HURRICANE CITY UTAH

Hurricane Planning Commission Meeting Agenda

August 25, 2022
5:00 PM

PRELIMINARY SITE PLAN FOR: RICHARD & KATHLEEN HINTON

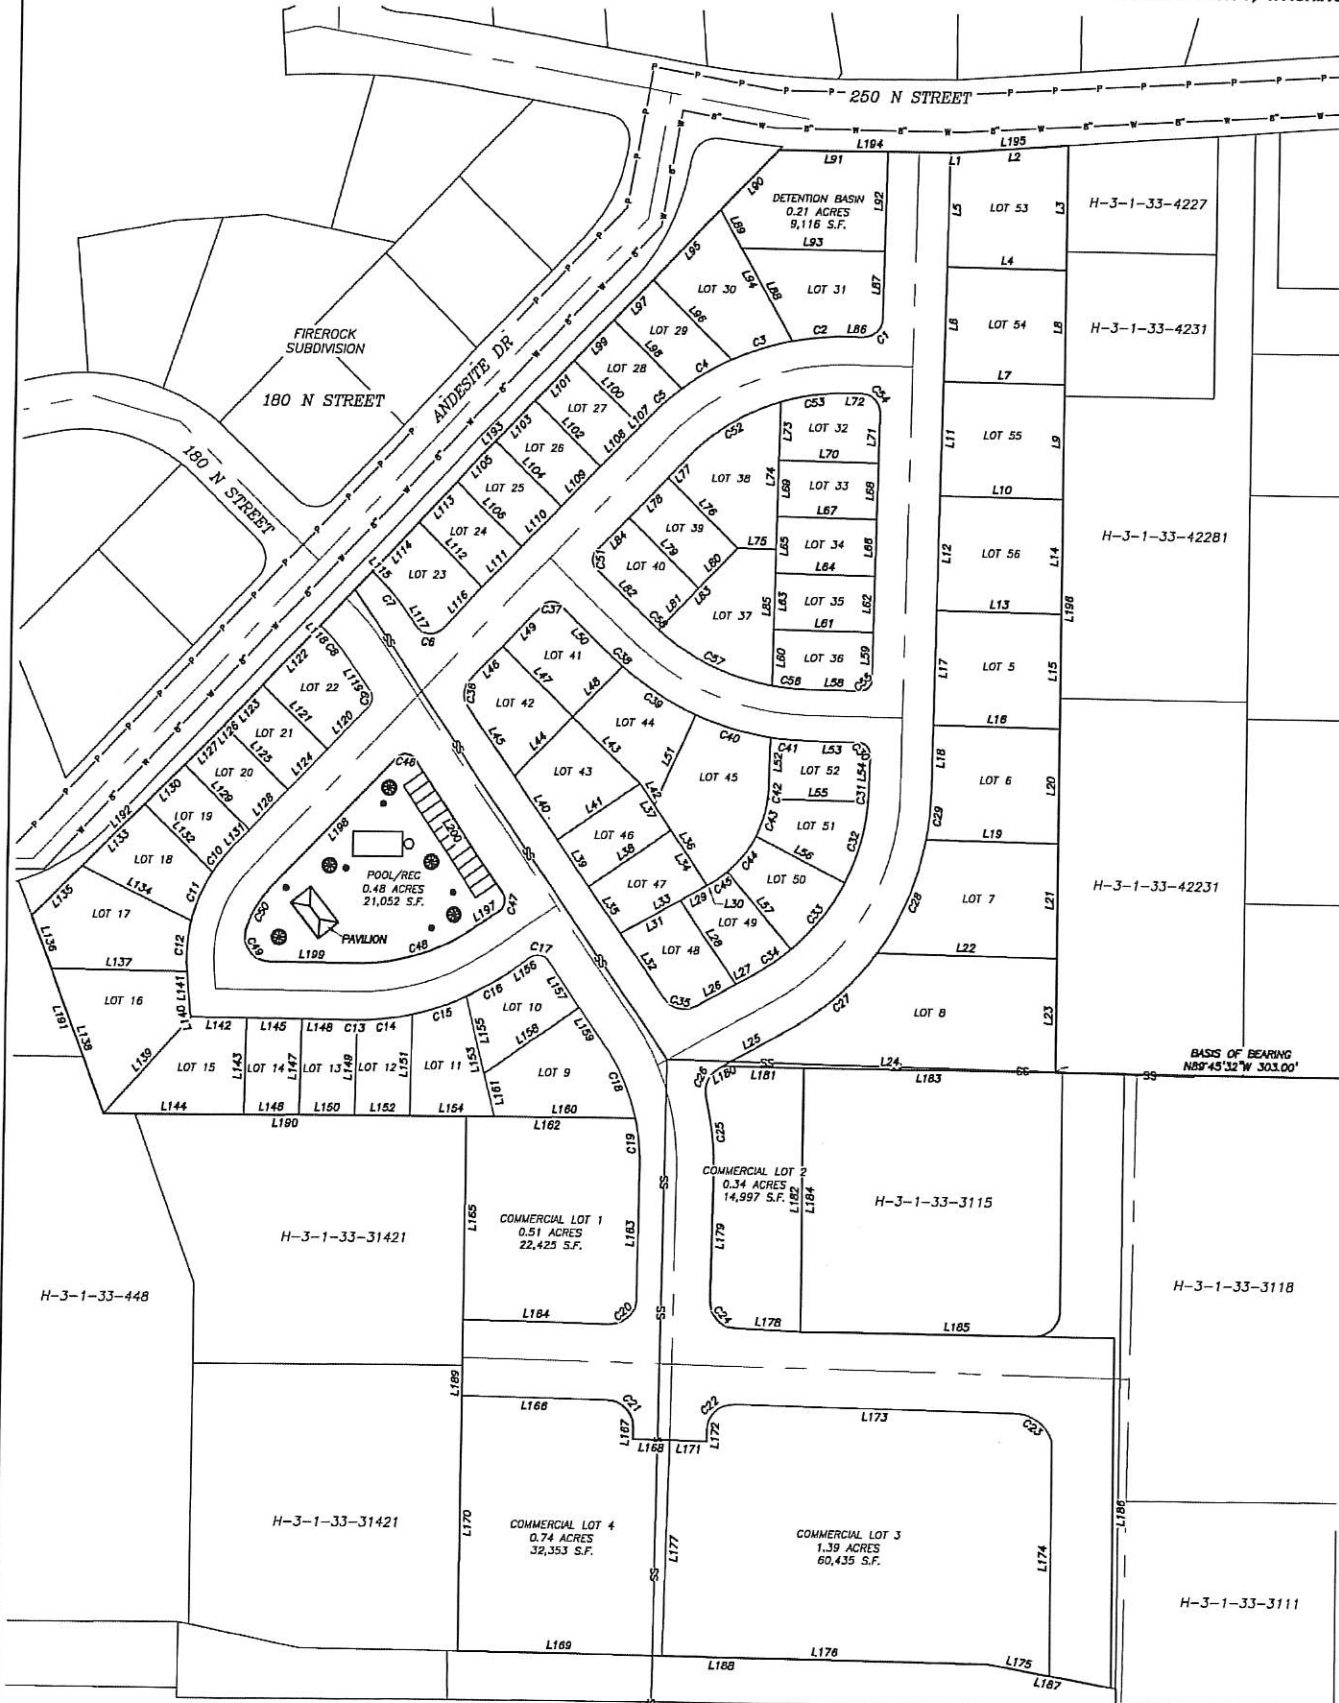
I have attached a Record of Survey showing a 66-foot easement across the property owned by Hinton Holdings, LLC ("Hinton"), which would encumber Commercial Lots 1, 3, and 4 shown on the proposed Preliminary Site Plan. I have also attached a Warranty Deed showing the easement is for the benefit of the neighbor, Porter Rockwell Executive Suites, LLC ("Porter Rockwell"). The easement appears to be a private (not public) easement.

Until an agreement is reached with Porter Rockwell to remove and/or relocate the easement, the 66-foot easement should, at a minimum, be shown on all site plans, construction drawings, and plats approved for the Hinton property. There are at least four provisions in the Code that apply to this situation:

For the Planning Commission meeting this week, my recommendation is that (1) the application be continued until the private 66-foot easement is added to the proposed preliminary site plan and (2) any approval be subject to (i) the execution and recording of any necessary agreements to abandon or otherwise resolve the 66-foot private easement issue; (ii) if the 66-foot private easement is not abandoned or otherwise resolved, the ability of all lots to comply with applicable standards, including access, utilities, and setbacks; and (iii) if the 66-foot private easement is not abandoned,

Update 8/25/2022: The Planning Commission continued this item to allow the applicant more time to work through the design. A new site plan has been submitted that allows the wetlands to remain in place and shows the easement on the south side of the property. Staff has two major concerns with this new site plan. The first is the density, for the zoning they've requested their maximum density is 44 units and they appear to show on their site plan 104 units, over double the allowed units, if they want this many units they would have to reapply for an RM-3 zone. The second concern is showing what appears to be parking along the eastern property boundary, there is no shown access to this parking area along the eastern boundary. The plan shows 256 parking spaces which is more than sufficient for 104 multifamily units. Overall staff does not recommend approving the site plan as presented

1. **Density:** The Preliminary Site Plan shows 52 units on 10.065 acres. This is a density of 5.16 units per acre. The max R1-8 PDO density is 4.4 units per acre. The applicant could ask for a density bonus; however at this time no density bonus has been requested.
2. The property owner to the west has come to city staff about an easement located on the south end of this property that would not allow it to be developed in the manner shown on the site plan. Staff is still investigating these claims at this time.
3. While it appears that there are double-fronted lots along Andesite Road, upon further review it appears there will be some open-space barrier between the homes and the road. There is an

Suggested connectivity roadways

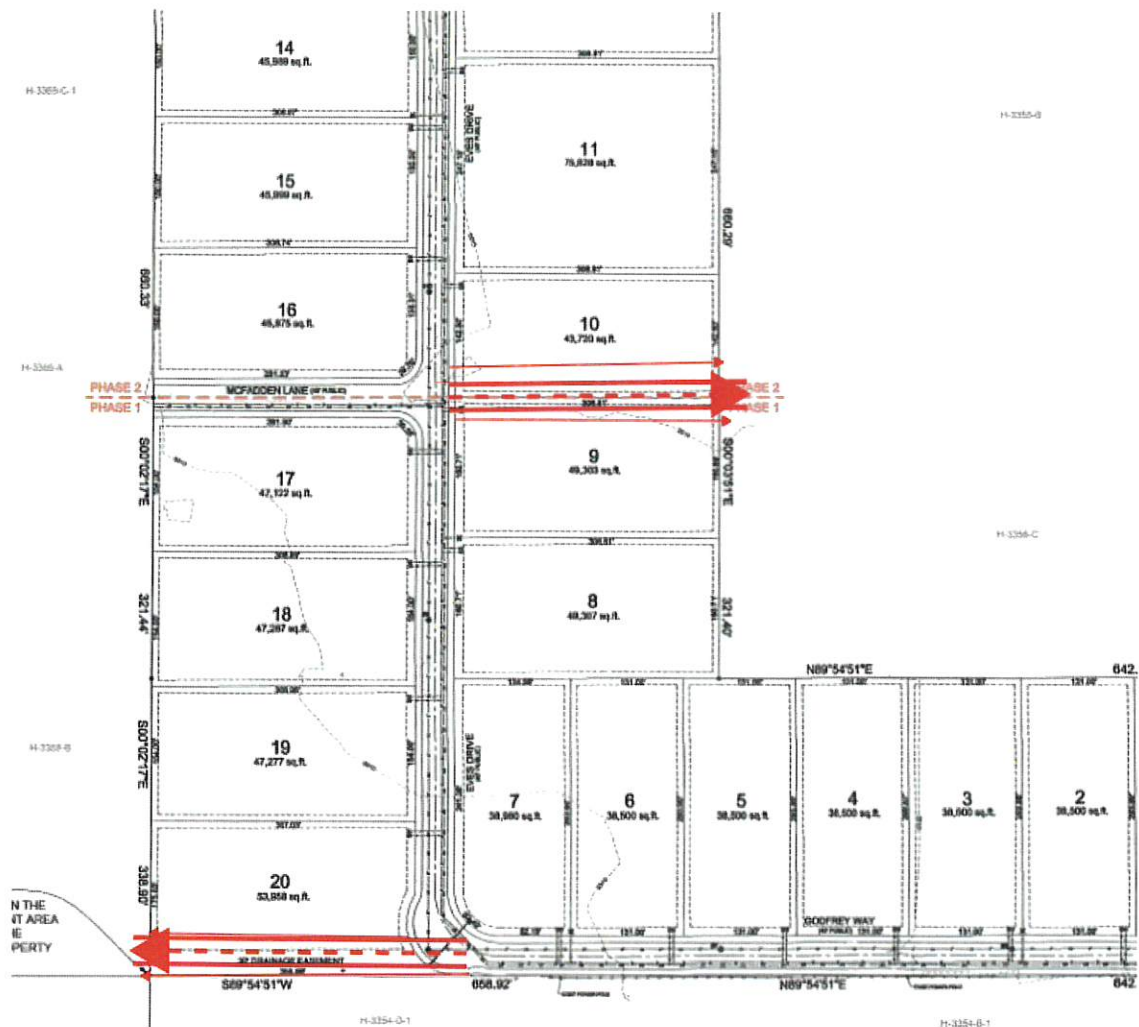
6. The plat does not show any connectivity to the property to the east and west. The southernmost roadway and the centermost roadway should continue across the property Hurricane City Code states:

Southern Dunes Townhomes location superimposed on the approved Sand Hollow Mesa site plan

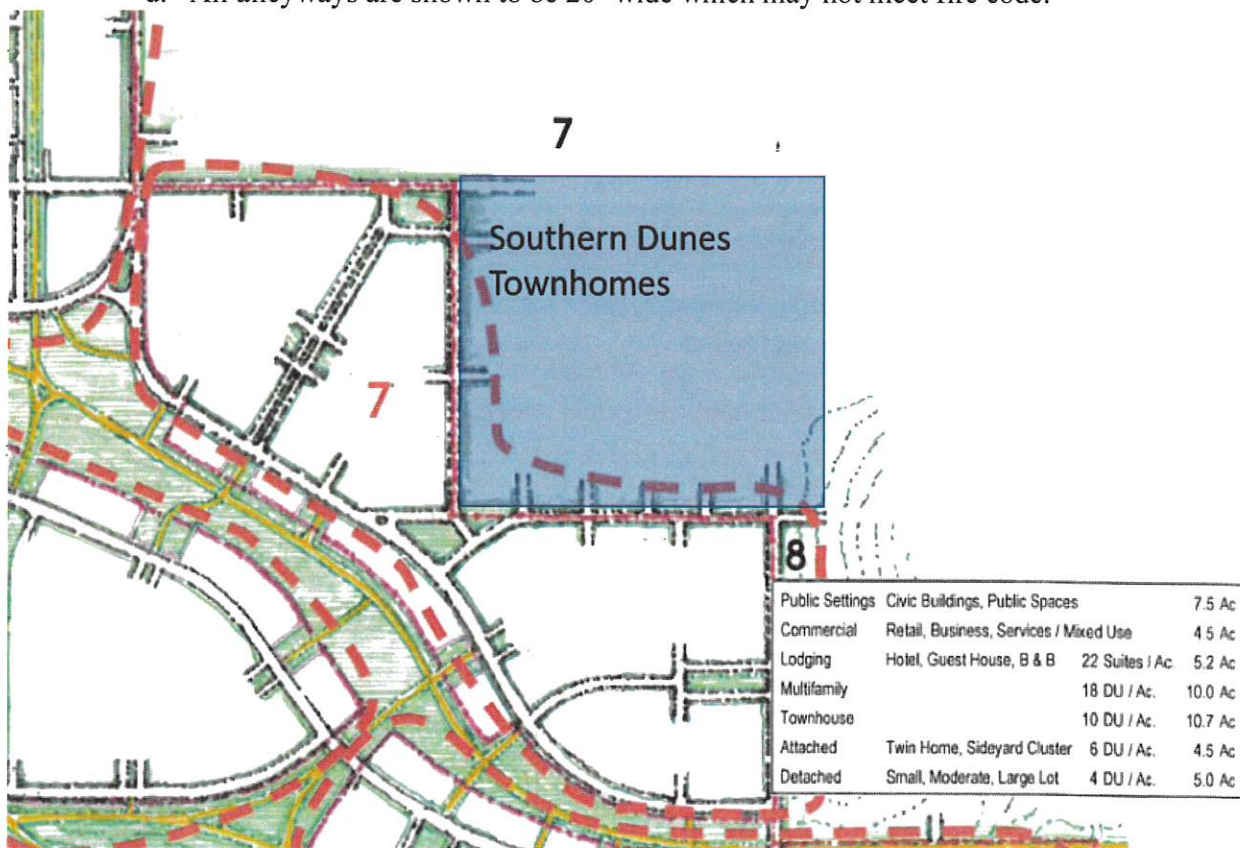
An couple of recommendation would be to have Road B connect all the way through the project. Have Road F make a conection to the North. Have Road D connect to the west.

- d. All alleyways are shown to be 20' wide which may not meet fire code.

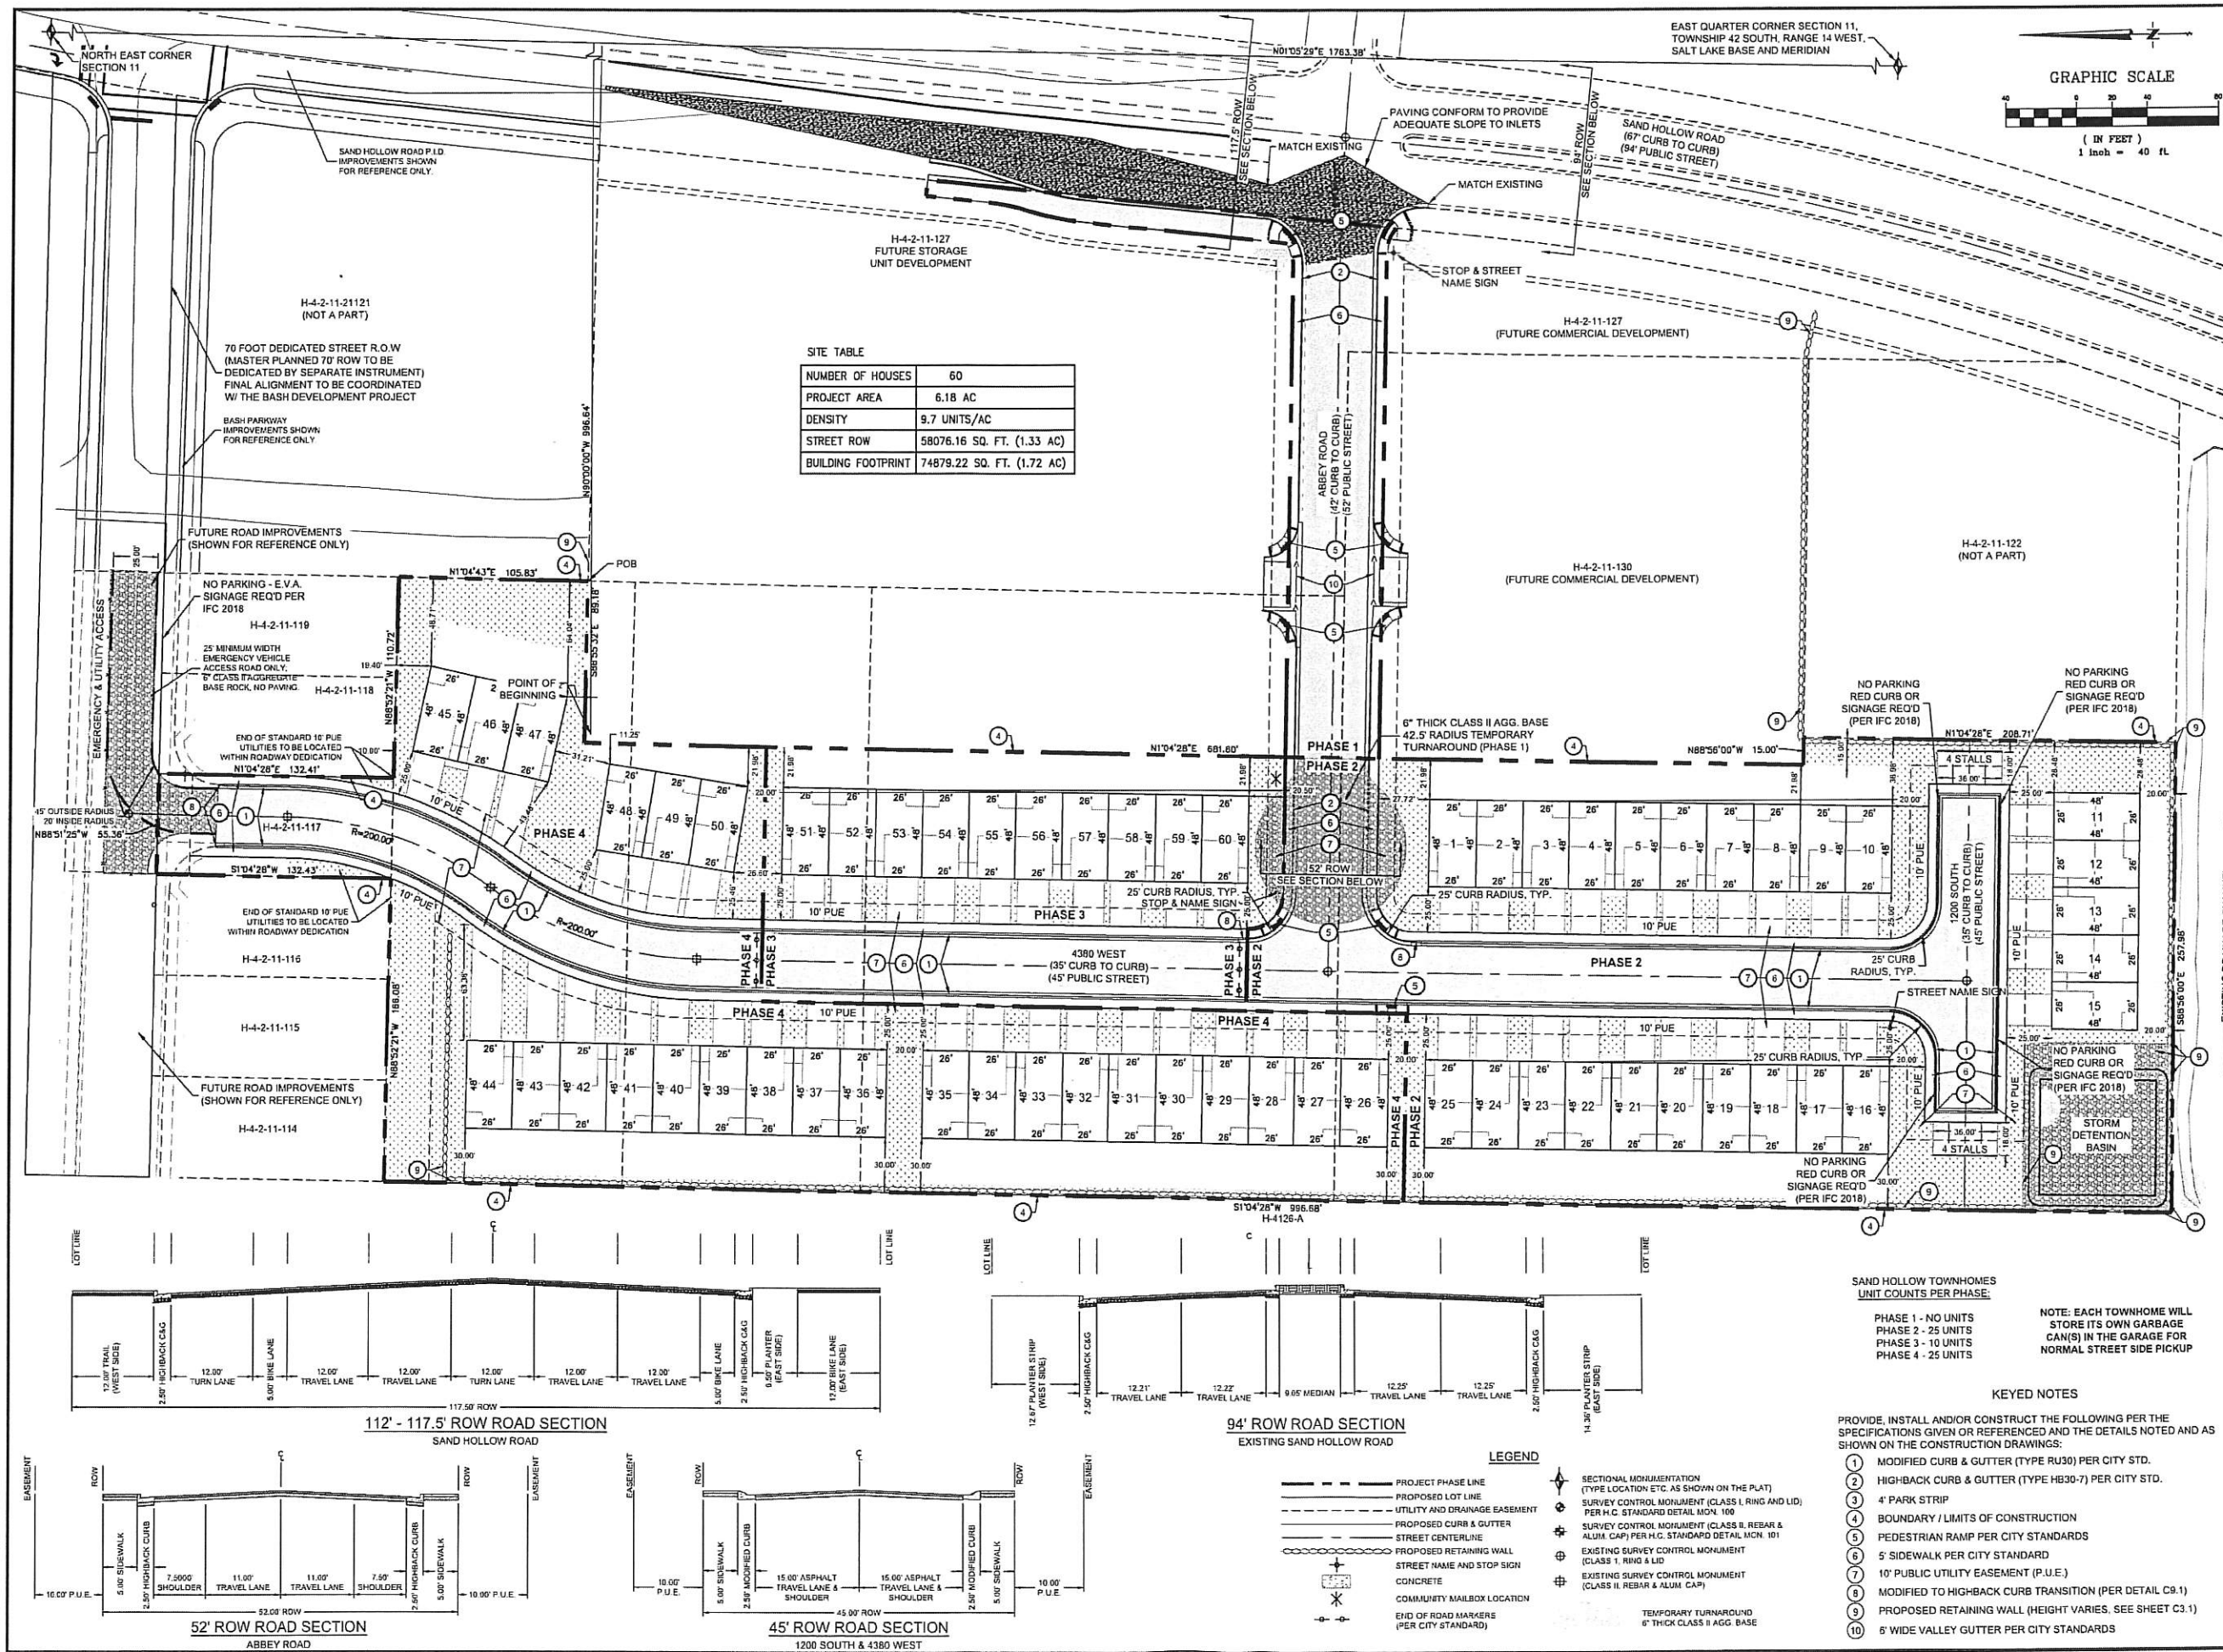
1. That the additional landscaping is provided to comply with City Code.
2. The applicant remove the eight parking spaces located within the hammerhead.
